# TOWN OF HUDSON

### **PUBLIC MEETING TOWN OF HUDSON, NH NOVEMBER 6, 2019**

| B. Flagstone Crossing Site Plan<br>SP# 09-19 | Lowell Rd. / Flagstone Dr.<br>Map 222/Lots 3, 4, 5, & 6 |

**PROJECT: SITE DEVELOPMENT PLANS FOR FLAGSTONE CROSSING**

SHEET TITLE: **SITE PLAN**

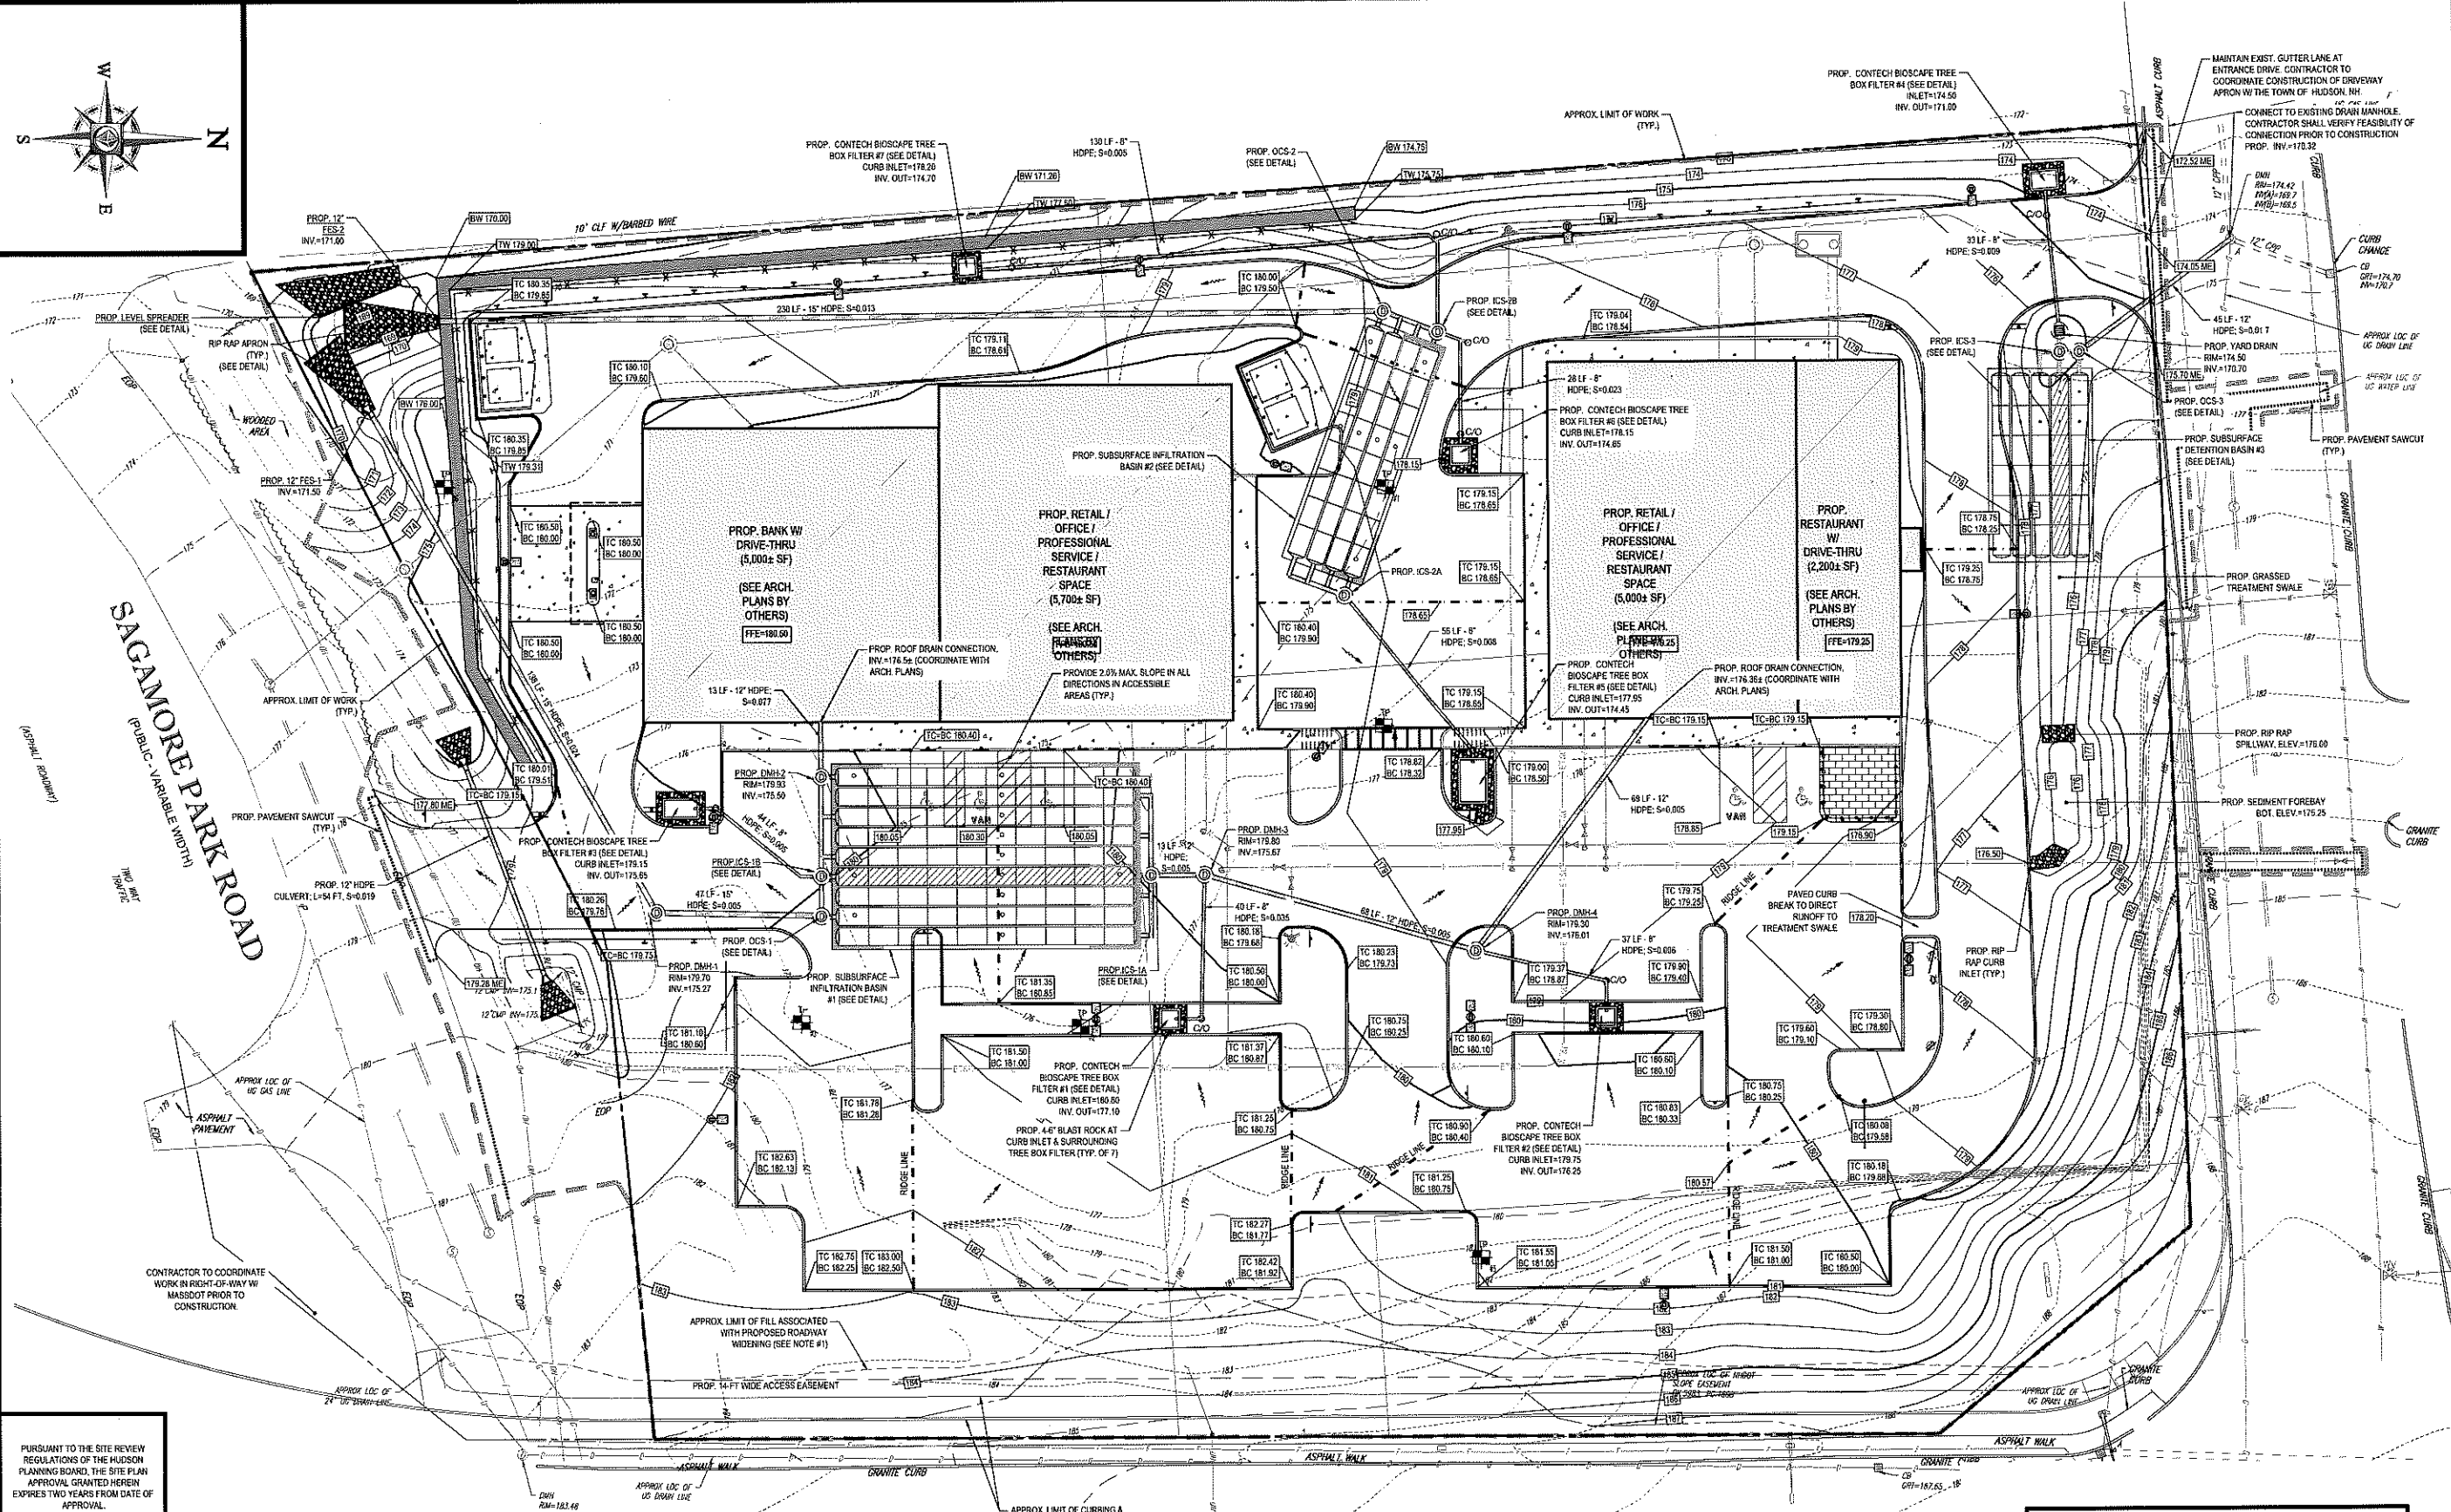
- j. On Sheet 4 of 17, Map 222 Lot 3 has the "proposed" and "existing" areas reversed. The applicant should review and correct.

**Response:**                    **The addresses of abutting property owners has been included on the plans, as shown on Sheet 4 of the enclosed Site Development Plans.**

**Response:** **Notation that the subject parcel does not fall within a special flood hazard area is included on Sheet 4 of the enclosed Site Development Plans.**

**Response:** The guide rail has been updated as suggested, as shown on Sheet 4 of the enclosed Site Development Plans.

**Response:** Proposed snow storage areas are noted on Sheet 4 of the enclosed Site Development Plans, and will be noted on the final plan.

ROADWAY PATCHING DETAIL

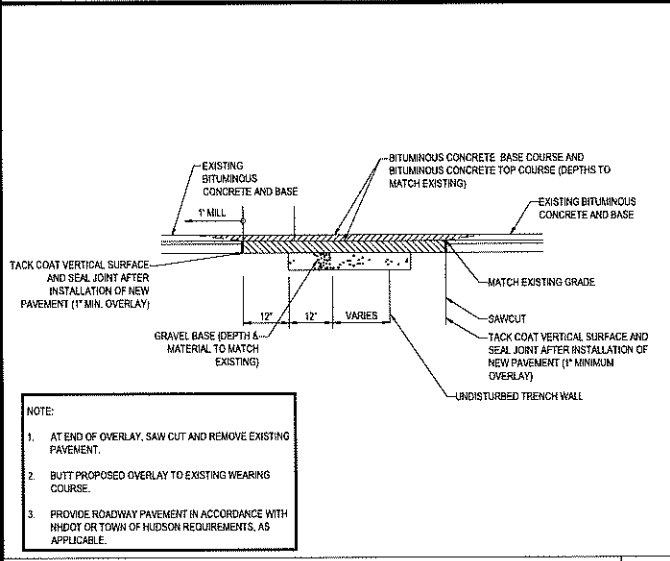
- e. *The applicant has provided a Roadway Patching detail that doesn't agree with the Town of Hudson's Construction Standard detail R-5. The fill layers should be stepped as shown in the Town detail.*

**Response:** **The Roadway Patching detail has been updated per the Town of Hudson's Construction Standard detail, as shown on Sheet 13 of the enclosed Site Development Plans.**
